MIL-PRF-83536/22
AMENDMENT 5
10 July 1999
SUPERSEDING
AMENDMENT 4
15 June 1999

PERFORMANCE SPECIFICATION SHEET

RELAYS, ELECTROMAGNETIC, ESTABLISHED RELIABILITY, 3PDT, LOW LEVEL TO 10 AMPERES, PERMANENT MAGNET DRIVE, HERMETICALLY SEALED, ALL WELDED, TRANSIENT SUPPRESSED DC COIL

This amendment forms a part of MIL-PRF-83536/22, dated 27 March 1992, and is approved for use by all Departments and Agencies of the Department of Defense.

FIGURE 1, delete and substitute:"

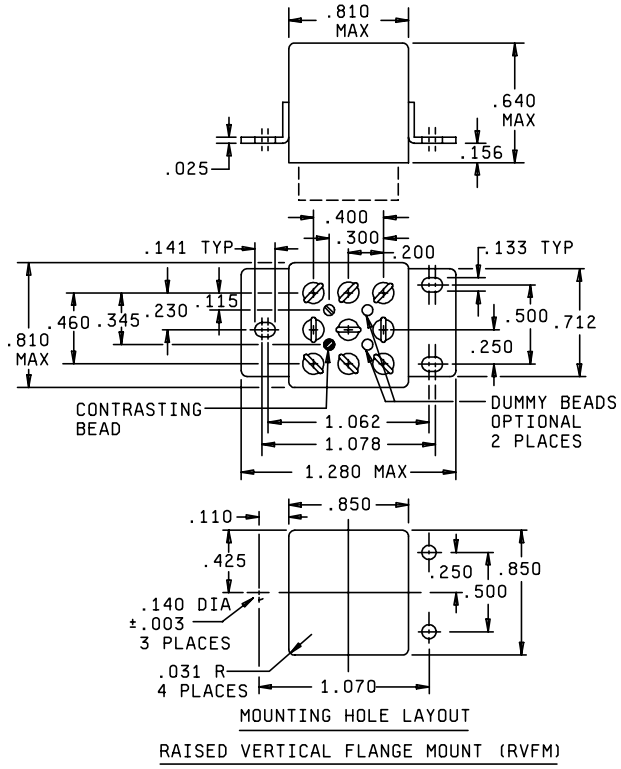
FIGURE 1, side view: Delete "SERIAL NUMBER SHALL BE MARKED ON TOP OF RELAYS" and "MARKING (EITHER SIDE)".

TRACK MOUNT

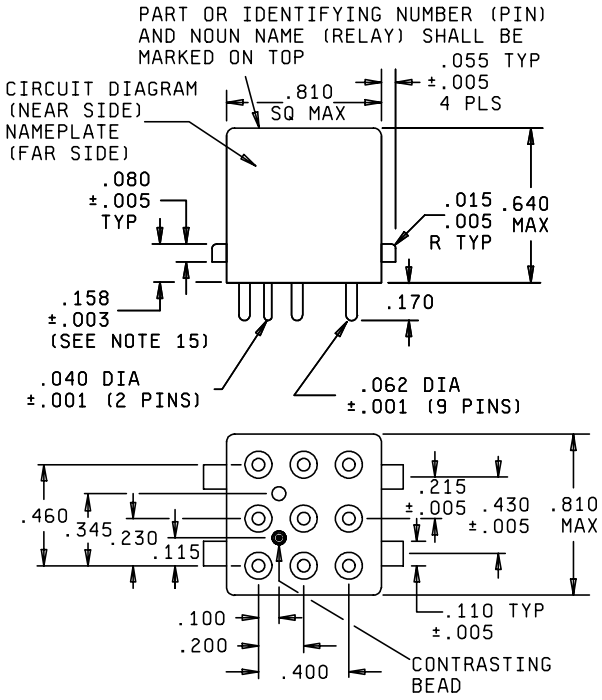
FIGURE 1, side view: Delete "SERIAL NUMBER SHALL BE MARKED ON TOP OF RELAYS".

FIGURE 1, side view: Delete "MARKING (EITHER SIDE)" and substitute "MARKING (SEE NOTES 8 AND 9)".

* FIGURE 1, delete and substitute:

CIRCUIT DIAGRAM
(ALTERNATE INTERNAL DIODE CONFIGURATION)

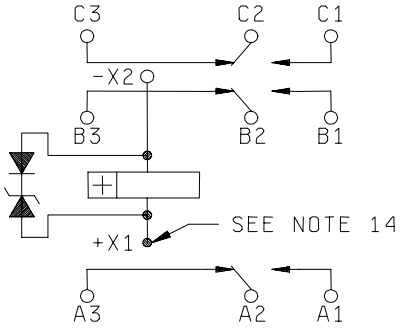
FIGURE 1, above figure title: Add "CIRCUIT DIAGRAM".

FIGURE 1, add the following circuit diagram:
